CMD 26-M7.8

**Written Submission from
Northwatch**

**Regulatory Oversight Report for Uranium
and Nuclear Substance Processing
Facilities in Canada: 2024**

Northwatch's
Written
Submission
January 2026

Map 2: Aerial photograph of BRR with the long-term monitoring plots (Plot A and B) and adjacent soil and vegetation sites (Sites 1, 2, 4, and 52) superimposed on the image.

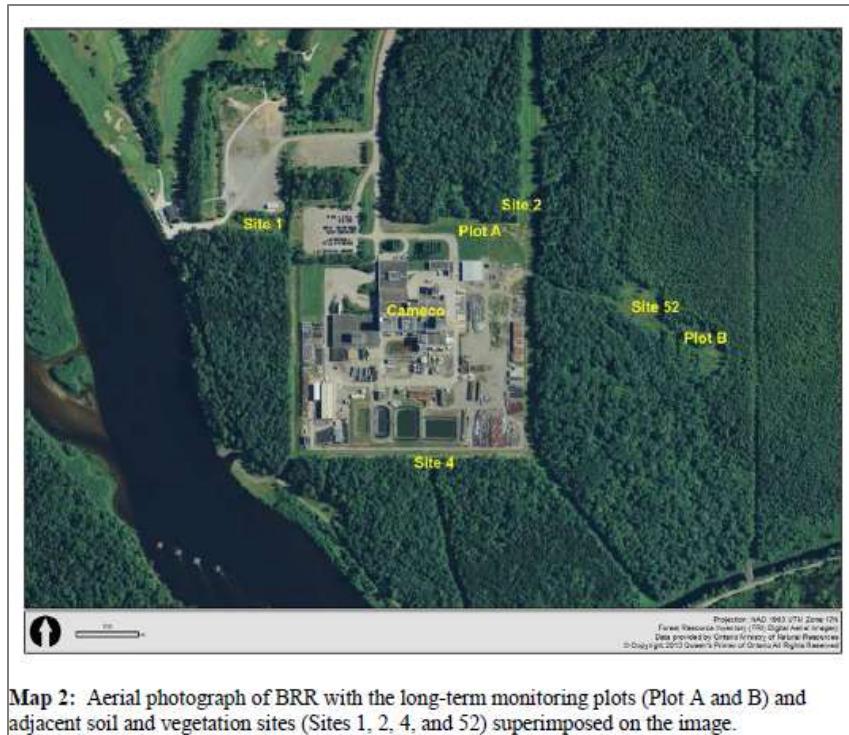
As with the Ministry's 2007 report and Northwatch's 2011 report, in the Ministry of the Environment's 2012 report a small number of the sampling sites showed increased concentrations; others remained relatively constant and a few showed decreases.

Figure 2: Uranium concentrations in surface soil (0-5 cm) collected in 2000, 2002, 2003, 2007, and 2012 from 12 sampling sites located in the vicinity of BRR.

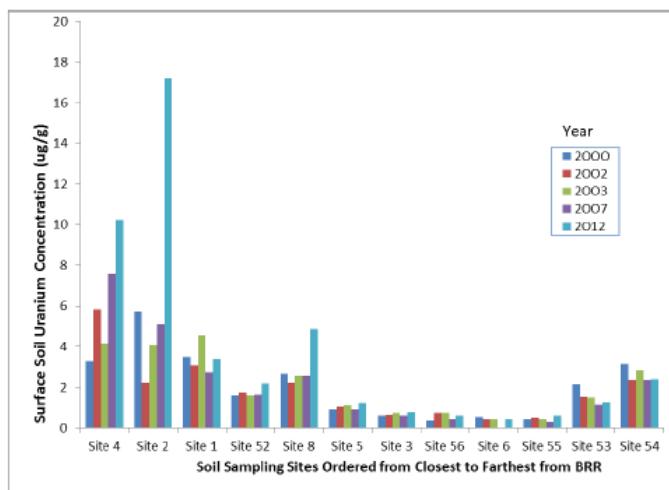
The MOE 2012 report indicated that the highest soil uranium concentrations in 2012 were reported at sites within 500 m of BRR (Sites 4, 2, 1, 52, and 8), consistent with MOE soil uranium data since 2000. As in the Northwatch 2011 report, Sites 2 and 4 results show the highest concentration of uranium, and MOE noted that in 2012 soil uranium concentrations were much higher at Site 2 than in previous years.

While the Ministry of the Environment does not, in their 2012 report, identify that the increased concentrations of uranium in the soil are having a measureable and adverse environmental effect, the sampling results do quite clearly show that the uranium refinery was to that point in time continuing to have a measurable impact in the form of increasing uranium concentrations in a majority of the sampling locations, as depicted in MOE's Figure 2.
